**SUBJECT: NOTICE OF PLANNED CHANGE AT NPDES OUTFALL 051,
NPDES PERMIT NO. NM0028355**

**LANL Radioactive Liquid Waste Treatment Facility (TA-50)
Proposed Process Schematic**

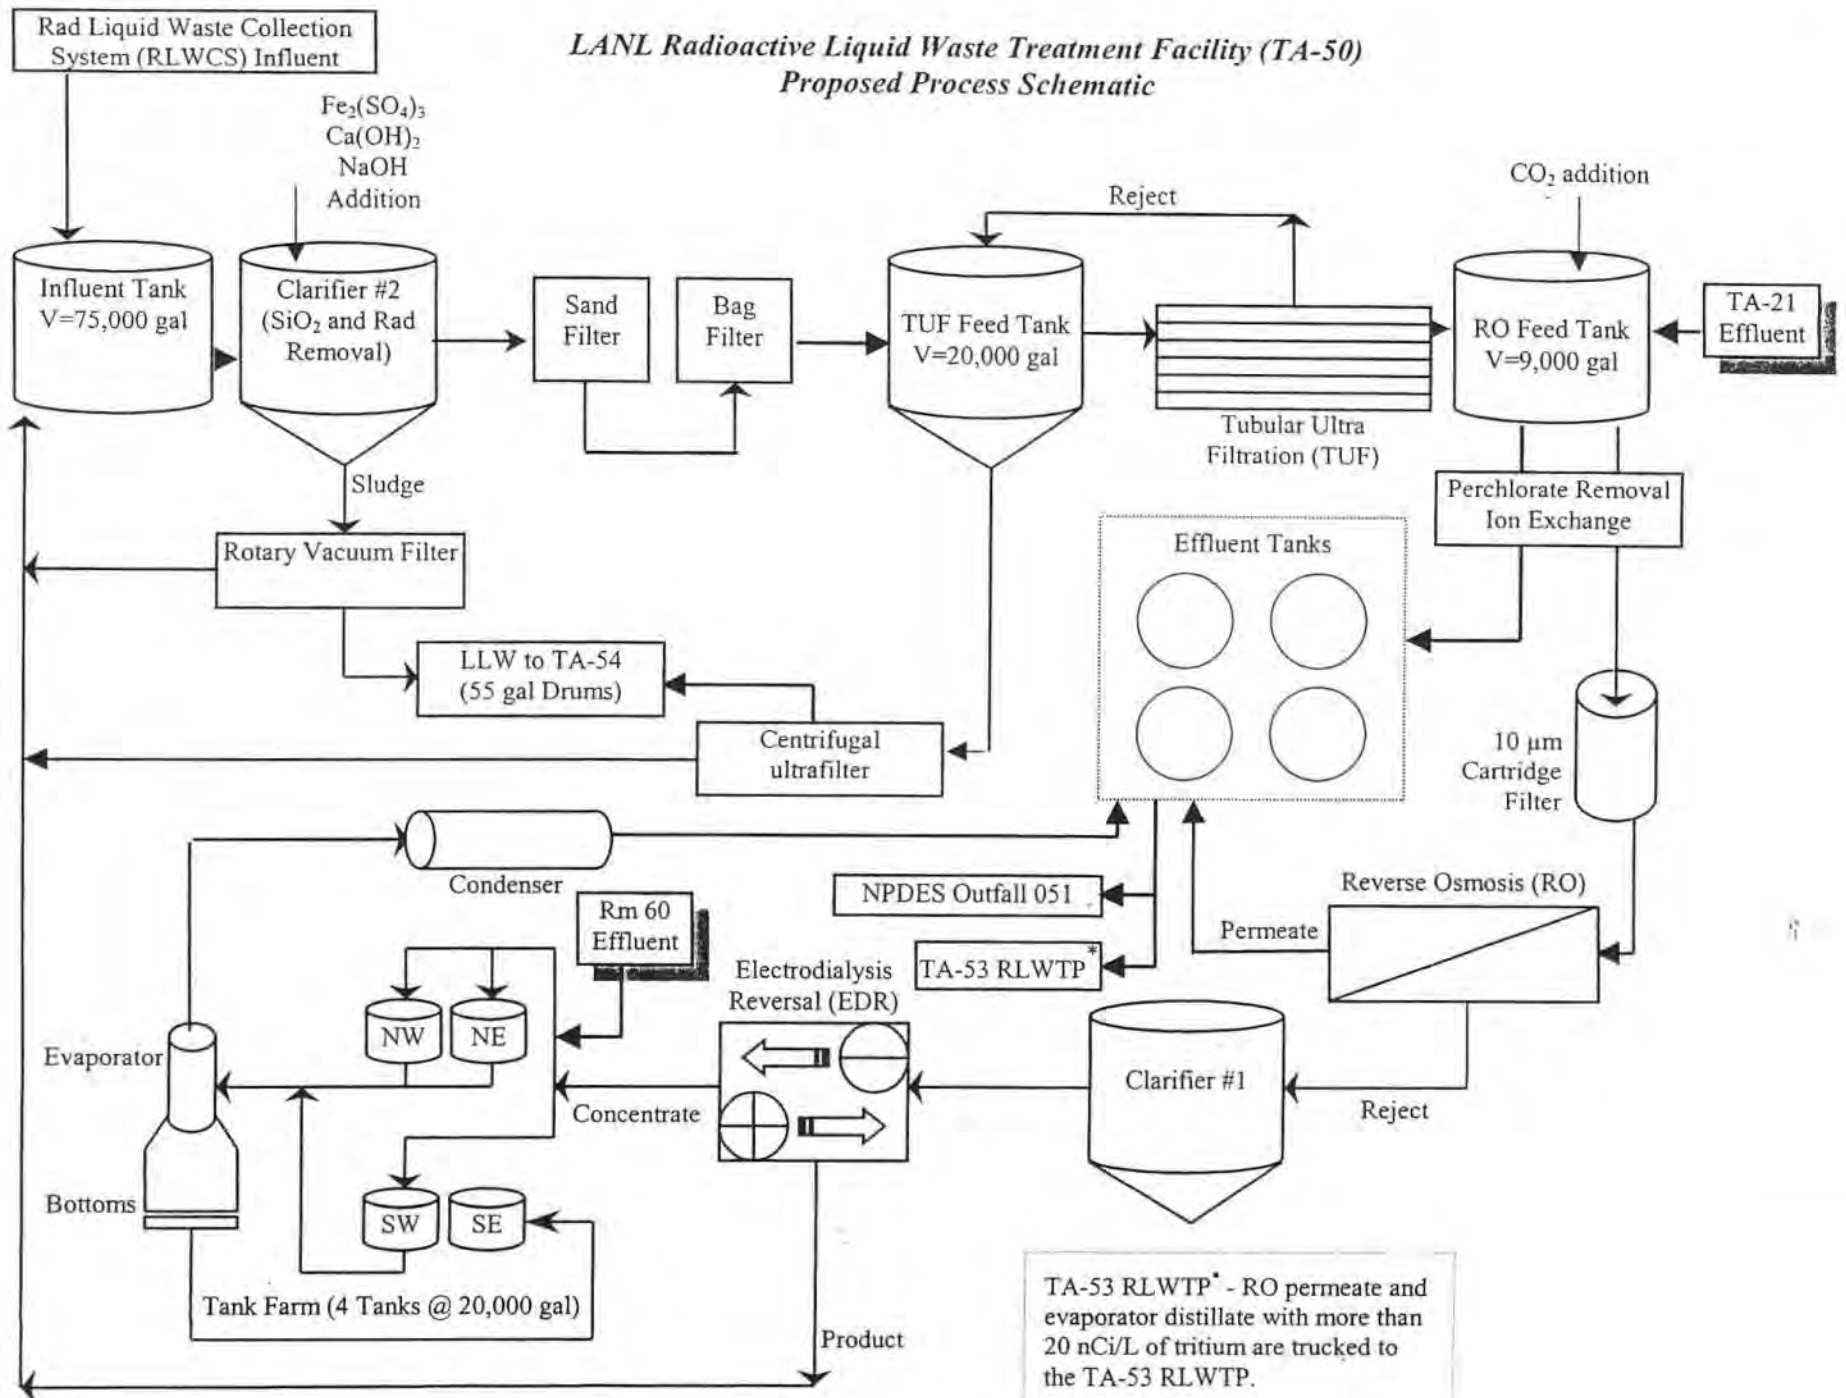
A strong base anion exchange resin, Sybron Inc. SR-7, is proposed for use. This resin has proven capability to remove the perchlorate in the effluent for more than 15,000 bed volumes. Installation of a perchlorate removal process using 54 cubic feet of SR-7 ion exchange resin will remove perchlorate from 23 million liters of effluent. This is approximately equal to one year of radioactive liquid waste effluent from the facility. All tubular ultra-filter effluent will be treated by the ion exchange process to remove perchlorate. Effluent from the ion exchange process will then be discharged to the environment via NPDES Outfall 051 or will be sent for further processing by reverse osmosis (See Enclosure 1).

Six ion exchange vessels in a parallel flow arrangement are proposed. Each vessel will treat 11.7 gallons per minute. Total flow through the columns, therefore, will be 70 gallons per minute. Resin vessels showing breakthrough of perchlorate will be removed from service and replaced with a new vessel with fresh resin. Ion exchange resin with chemically attached perchlorate ions will be incinerated off-site. It is expected that the treatment upgrade to the TA-50 RLWTF will significantly improve effluent discharged at NPDES Outfall 051. Estimated completion date for this project is March 31, 2002.
